ADDENDUM No. 1

UNION GROVE STATE PARK DESIGN GUIDE CABIN TAMA COUNTY, IOWA PROJECT NUMBER: 13-05-86-01

JULY 19, 2013

BY REVISION

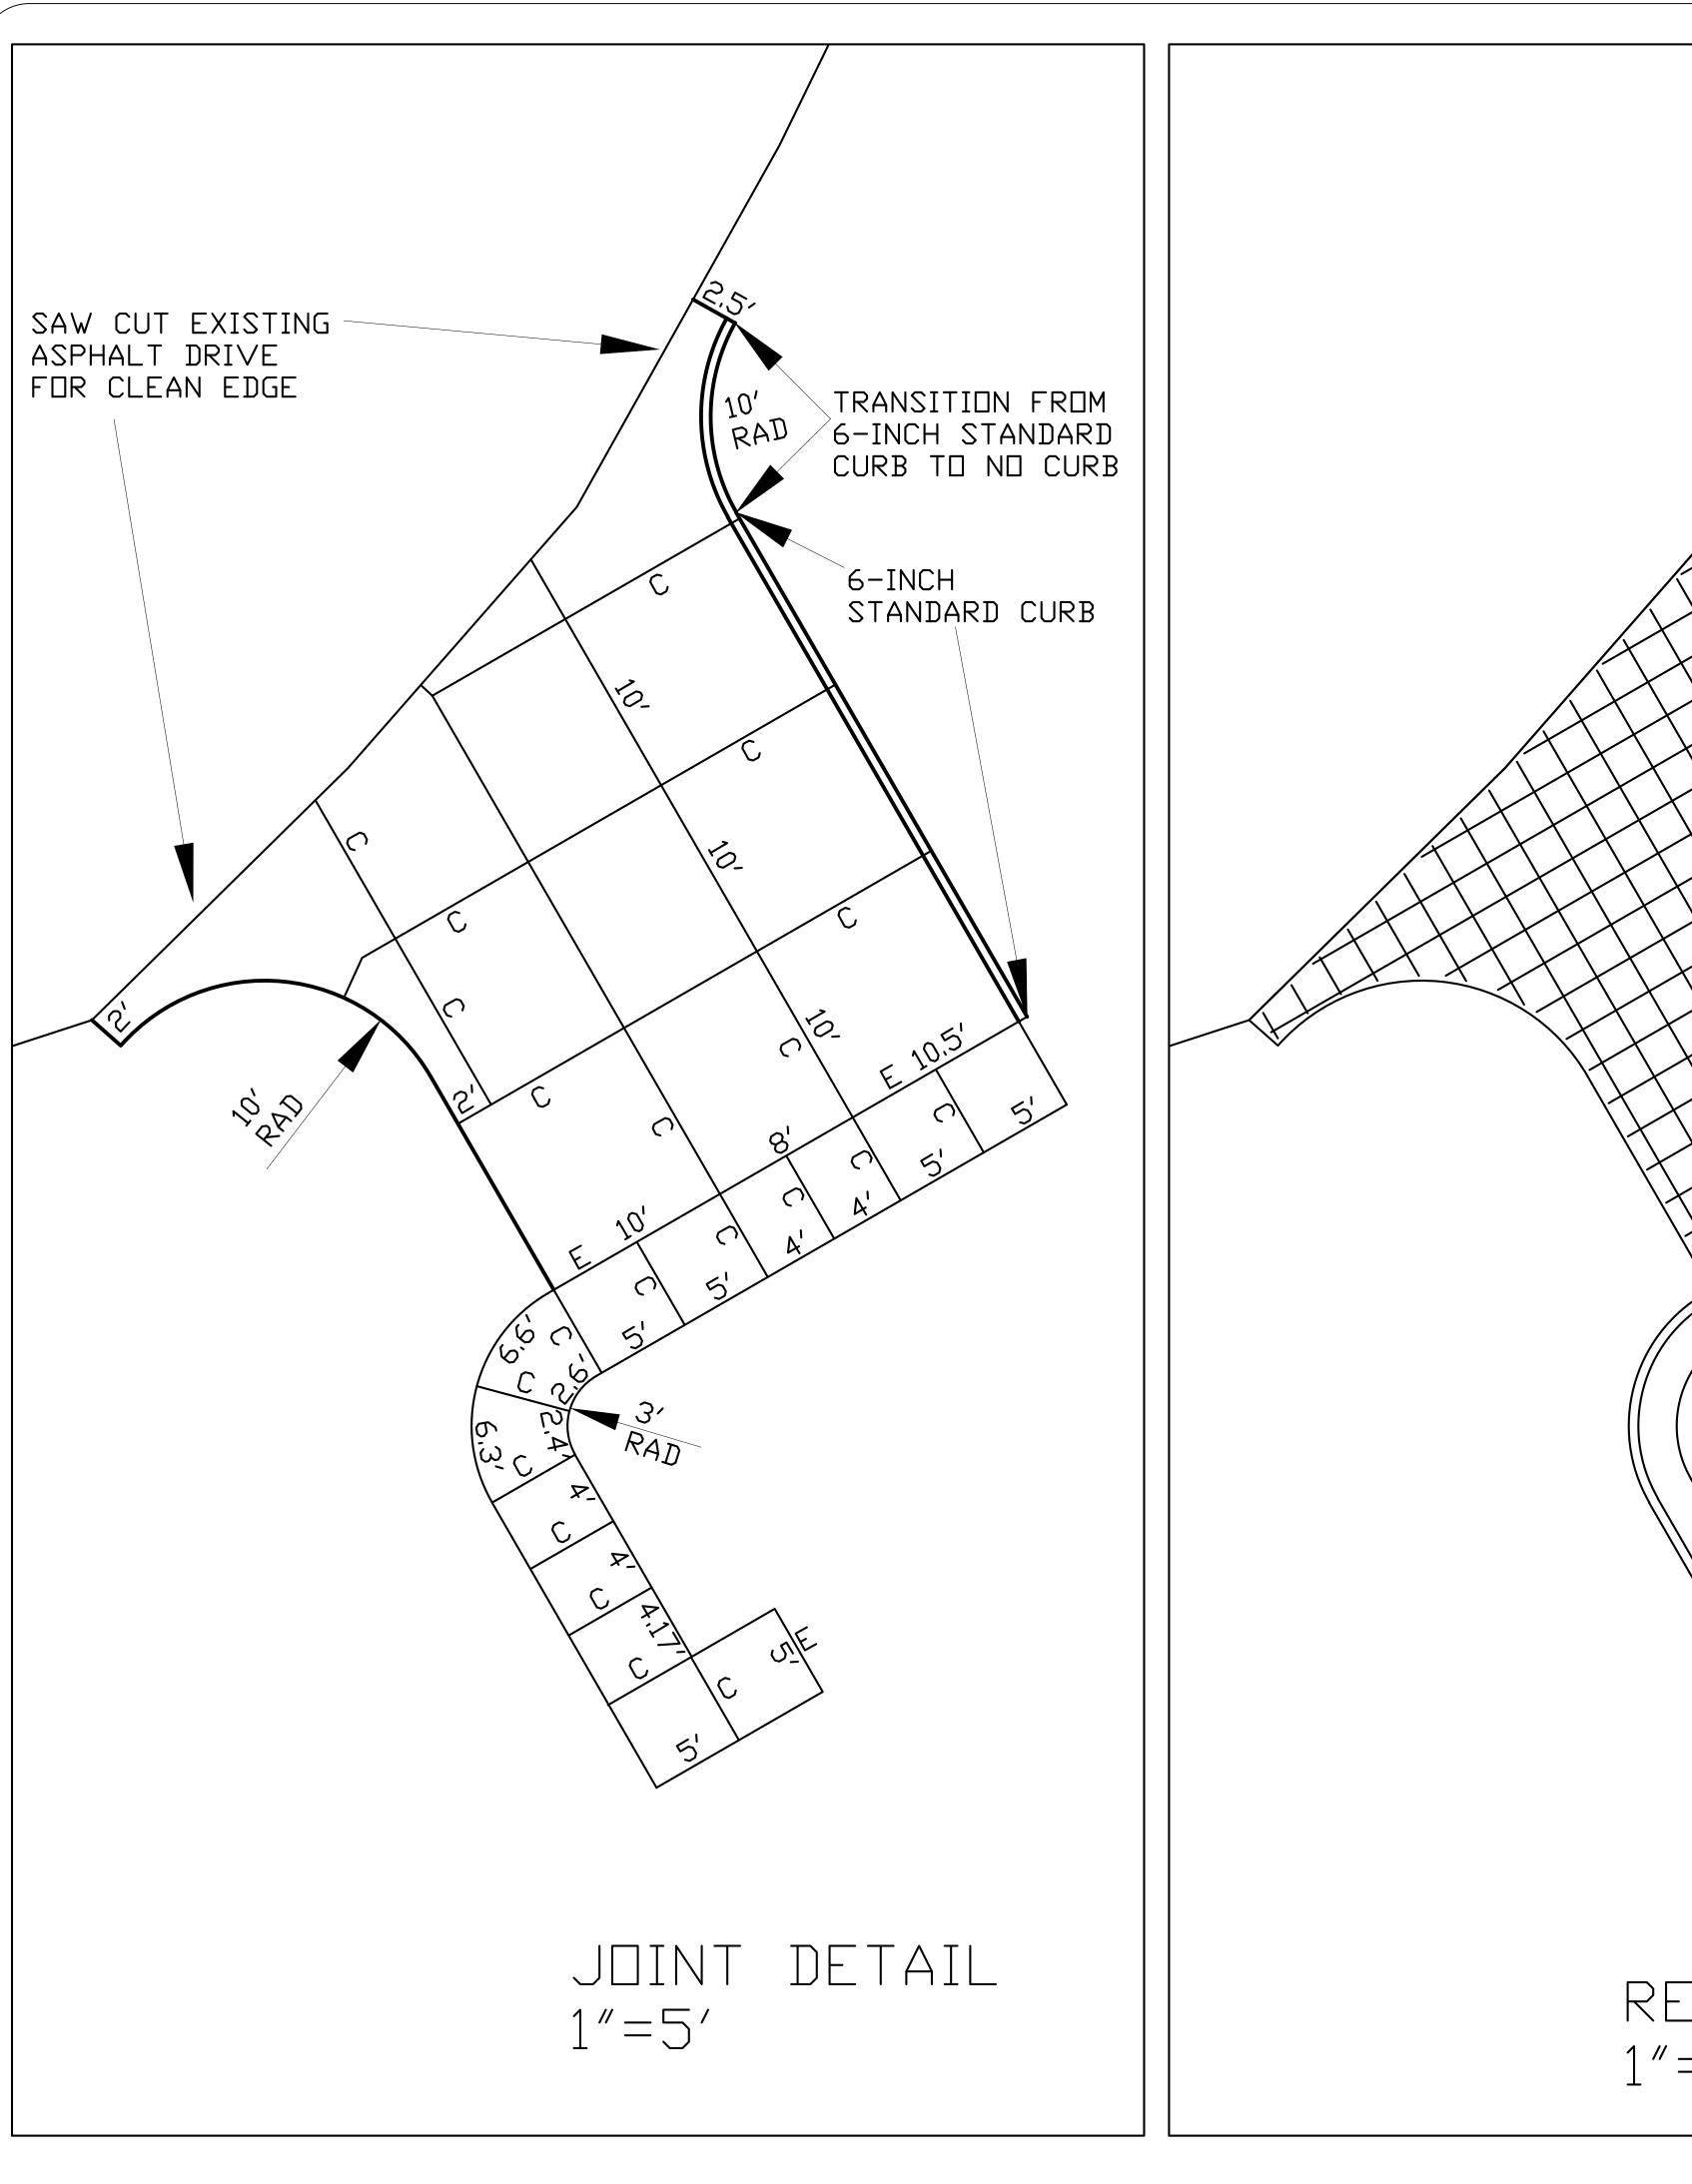
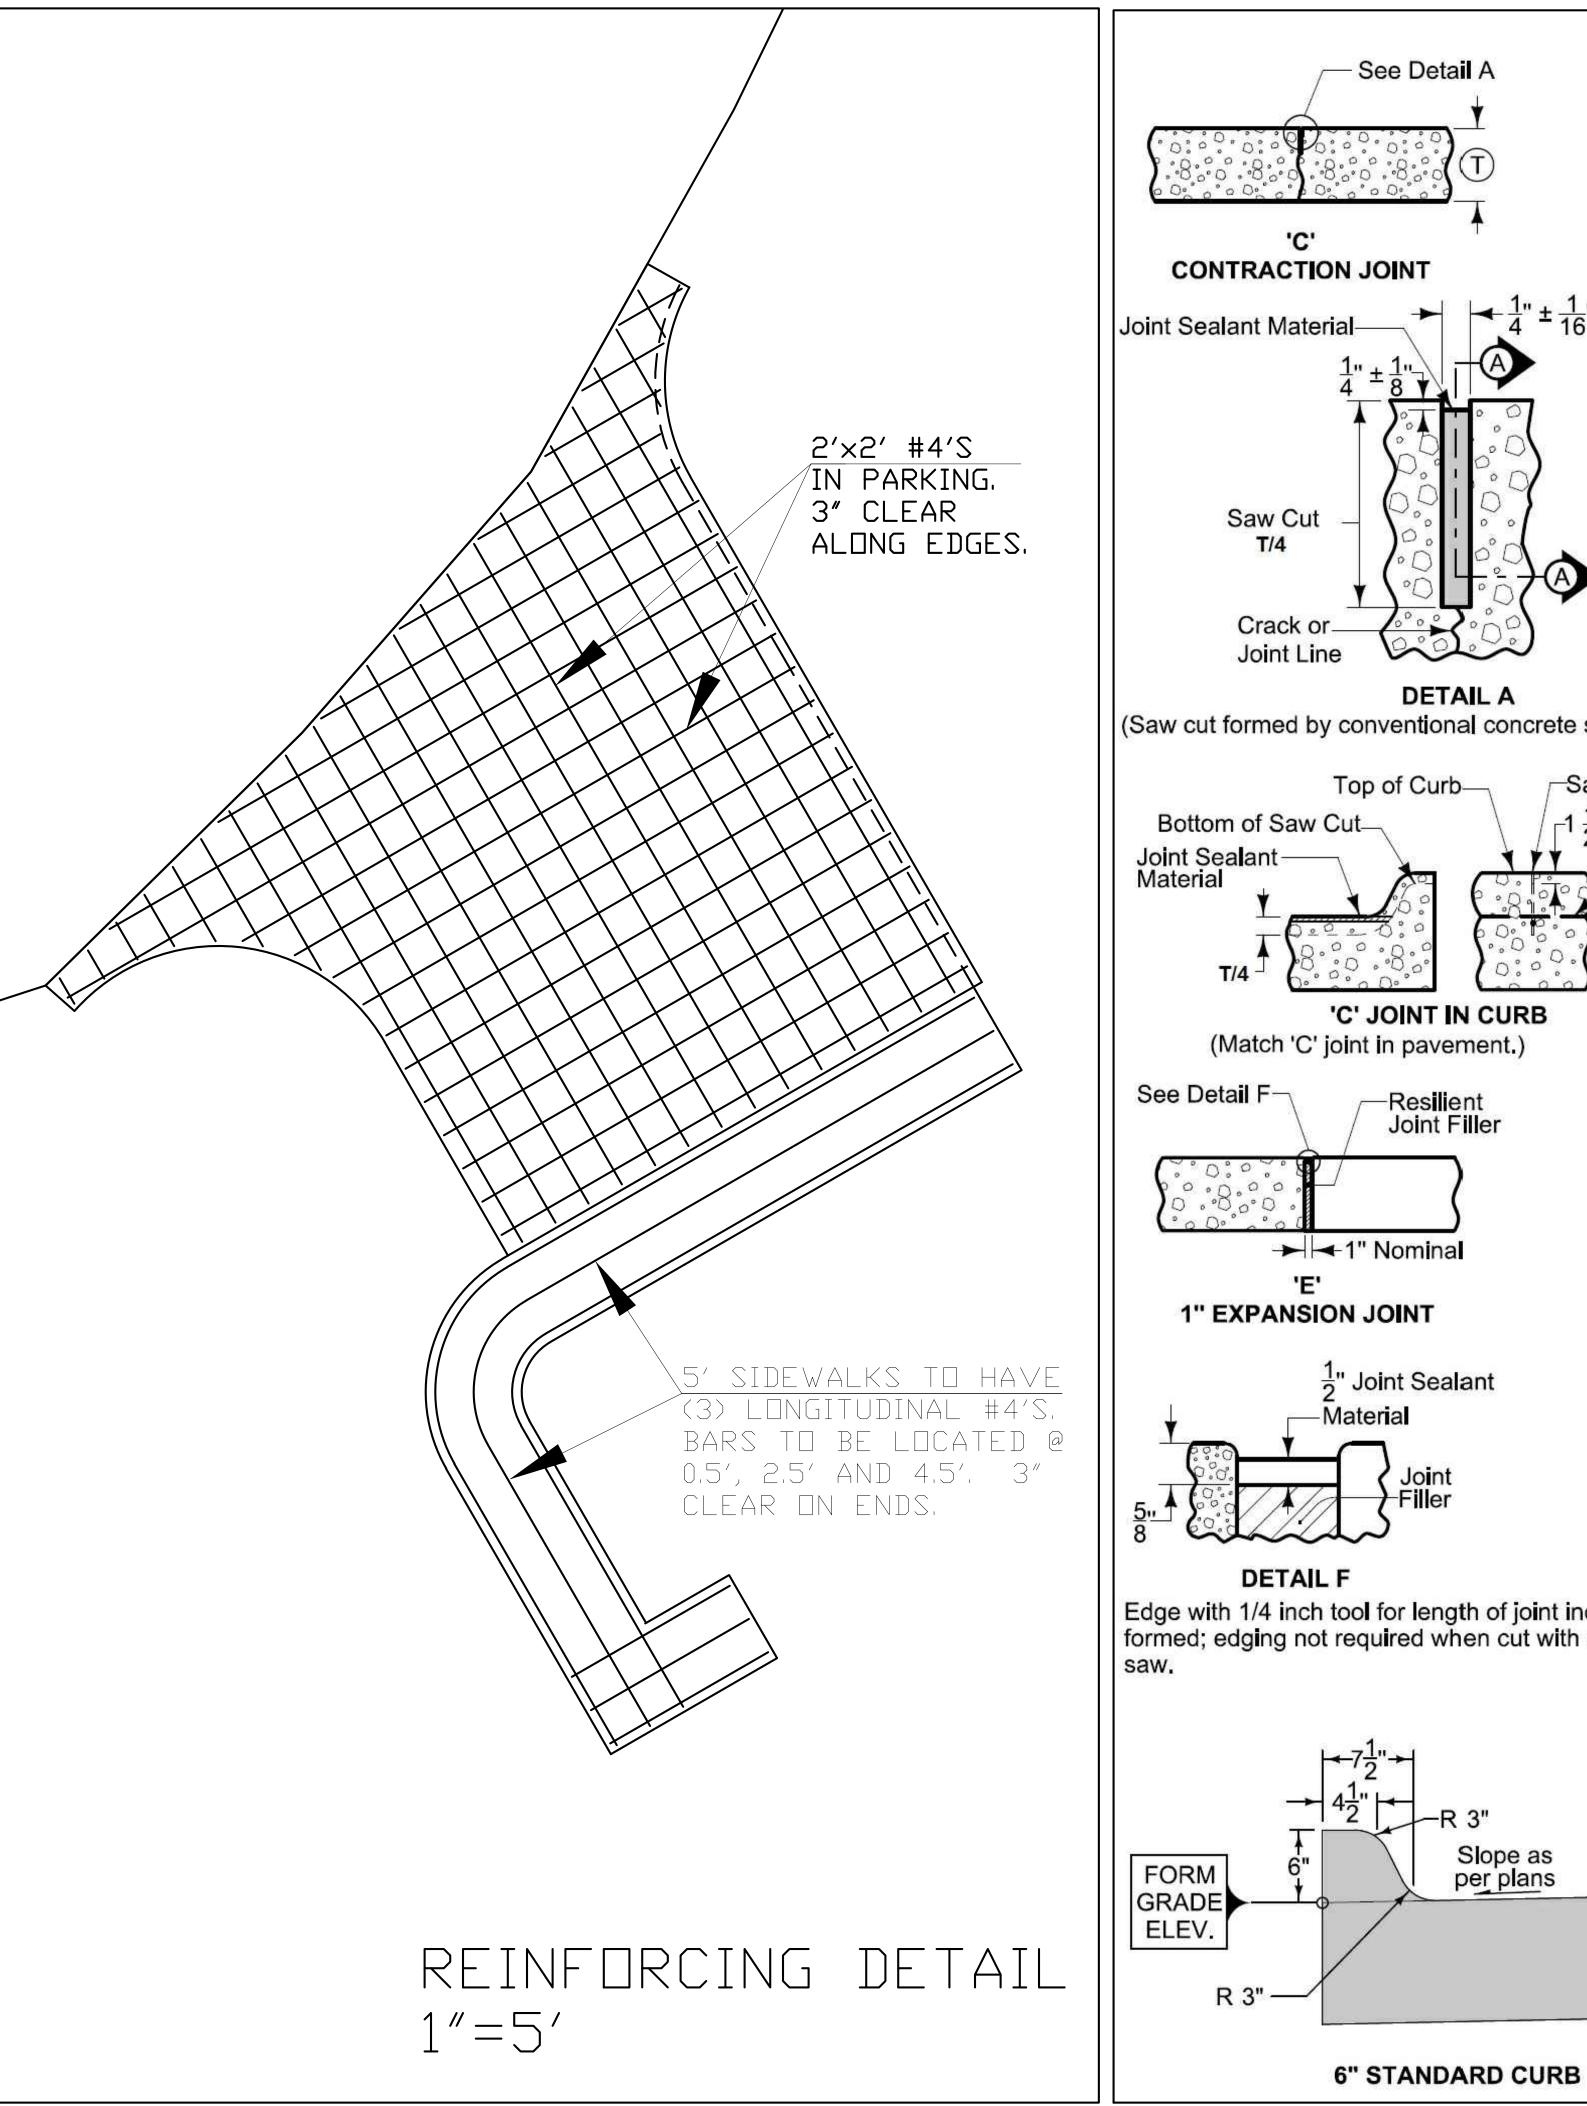
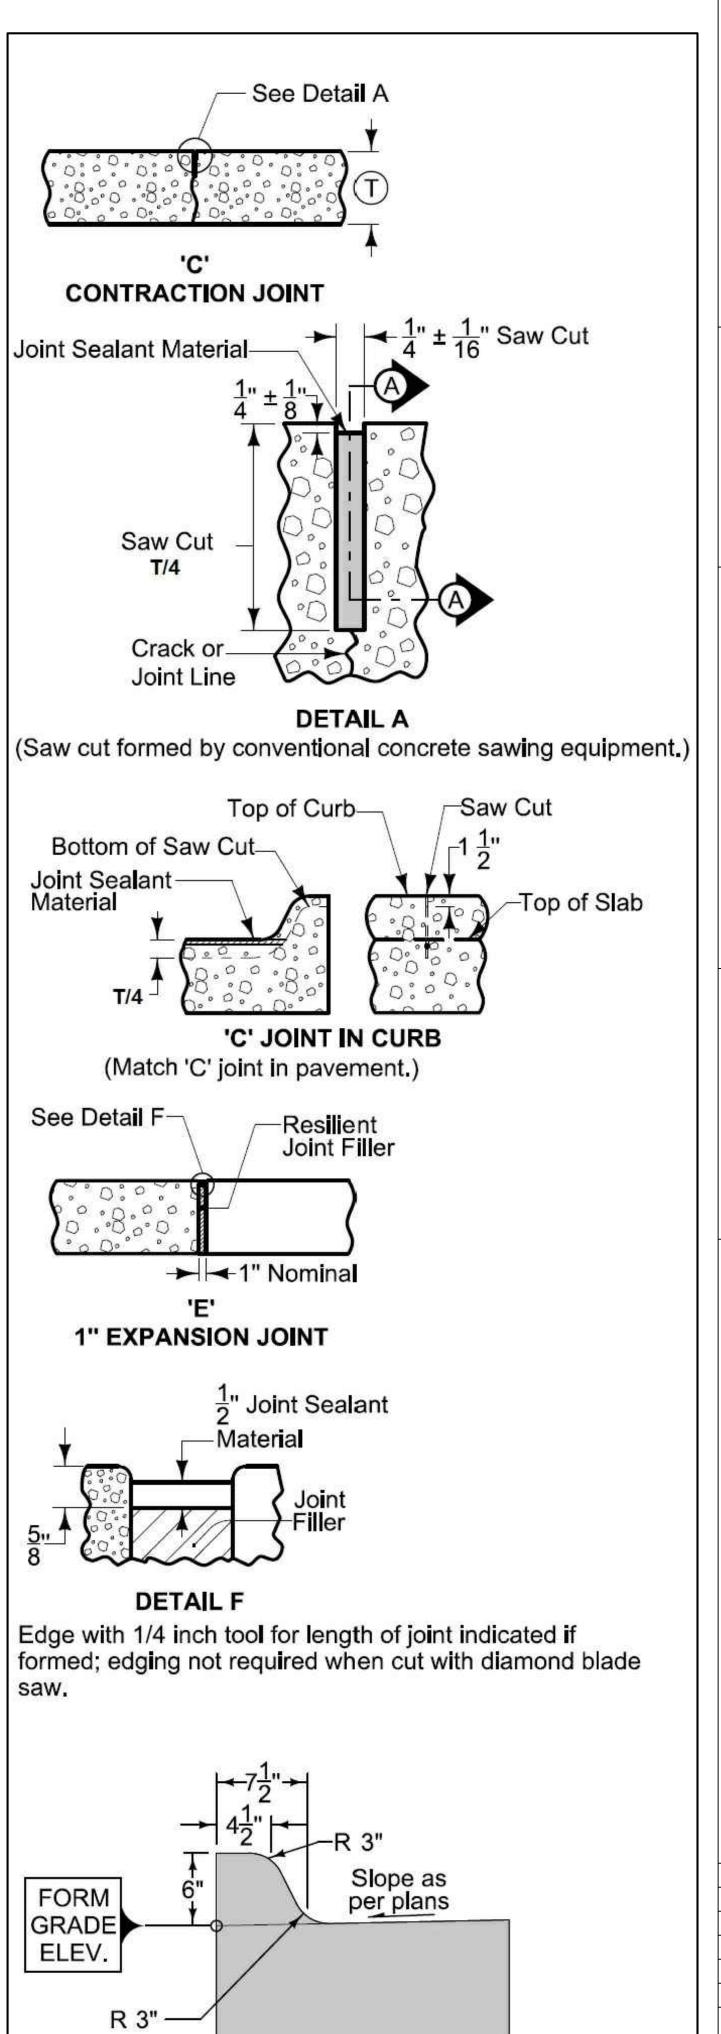
- 1. CIVIL PAGES C2 THROUGH C6 HAVE BEEN SUPERSEDED, PLEASE REFER TO THE ATTACHED NEW C2, C3, C4, C5 AND C6 PAGES AND REVISED QUANTITIES ON PROPOSAL SHEET ATTACHED.
- 2. DOOR 103 TO BE REPLACED WITH 4'-0" X 7'-0" SLIDING BARN DOOR AS SHOWN ON SK-1 ATTACHED.
- 3. HEAVY TIMBER TRUSSES TO BE ENGINEERED BY BUILDING SUPPLIER, PLEASE REFER TO SKETCH SK-2, ATTACHED FOR MORE INFORMATION. TRUSSES TO RECEIVE TWP 100 SERIES STAIN, COLOR TBD.

SK-1

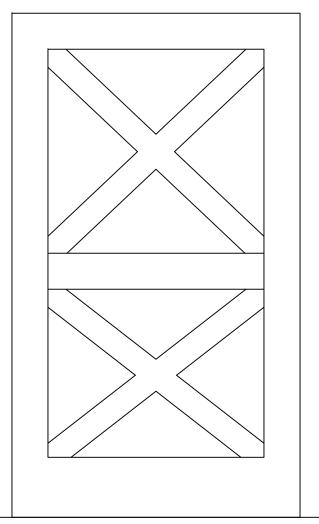
DOOR 103 IN BEDROOM SHALL BE REPLACED WITH THIS 4'-0" WIDE X 7'-0" TALL X 1 3/4" THICK SOLID MAPLE CROSS-BRACED DOOR SLAB ON BLACKENED BARN DOOR FLAT-TRACK HARDWARE BY ROGERS-WILCOX (RWH-105-SET-8-STD)
